SERVICE BULLETIN

Classification: EL01-007	Reference: NTB01-021	Date: March 23, 2001
-----------------------------	-------------------------	-------------------------

2000-2001 MAXIMA; SUNROOF GLASS OPERATES BY ITSELF

APPLIED VEHICLE(S): 2000-2001 Maxima (A33)
APPLIED VIN(S): Vehicles built before: JN1CA31A41T111687
JN1CA31A21T315646
JN1CA31D01T625644
JN1CA31D11T828977

Figure 1

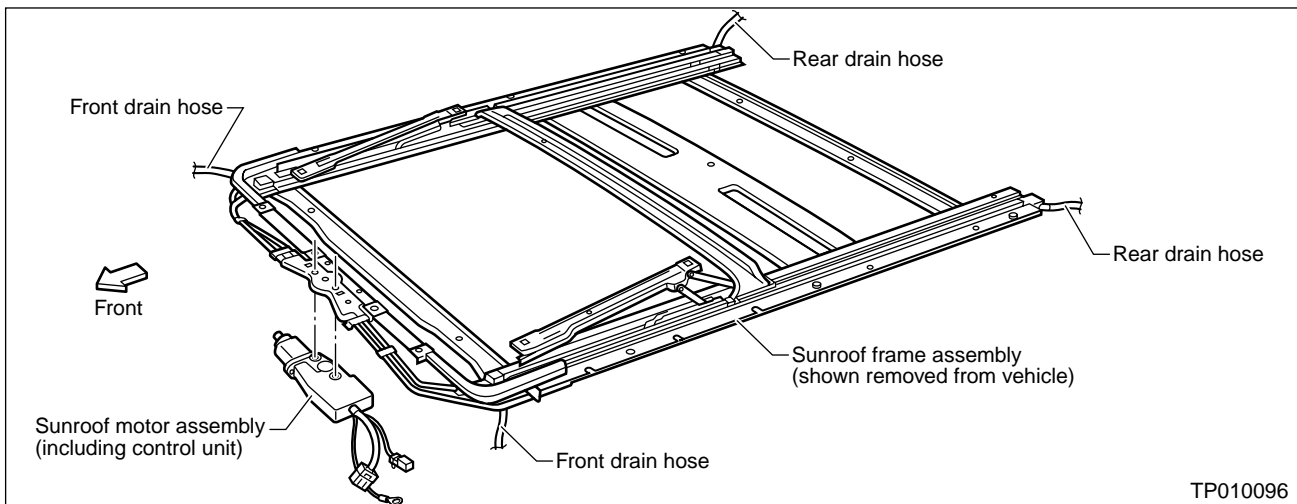
If the sunroof of an Applied Vehicle operates without the switch being pushed, it may be because of water contamination of the sunroof motor assembly. This could occur if the sunroof frame assembly is not draining correctly. A replacement sunroof frame assembly is available which allows for better draining if this incident should occur.

- A. Pour a small amount (less than 1 cup) of water into the front of the sunroof frame assembly, at the location of the front drain hoses (see Figure 1 on page 1 of this bulletin).
 - B. Watch for water draining into the wheelhouse areas at all four corners of the vehicle.
 - If water can be seen draining from the hoses, proceed to step 5.
 - If not, clear the hoses (refer to the BT section of the appropriate Service Manual) and then proceed to step 5.
5. Replace the sunroof motor assembly and the sunroof frame assembly with the ones from the Parts Information section of this bulletin. Follow the instructions in the BT section of the appropriate Service Manual.

3. Remove the plastic cover plate from the sunroof motor and inspect the circuit board:
 - If the circuit board is wet or is corroded, water is not draining correctly from the sunroof tray. Replacement of the sunroof motor AND the sunroof tray with the one listed in the Parts Information section of this bulletin is needed.
IMPORTANT: First, check the sunroof drains. See step 4 below.
 - If the circuit board is not wet or corroded, check for other possible causes of the incident. Refer to the EL section of the appropriate Service Manual for diagnosis of the sunroof switch and/or its circuits.
4. With the vehicle parked on a level surface, check the sunroof drains for blockage as follows:
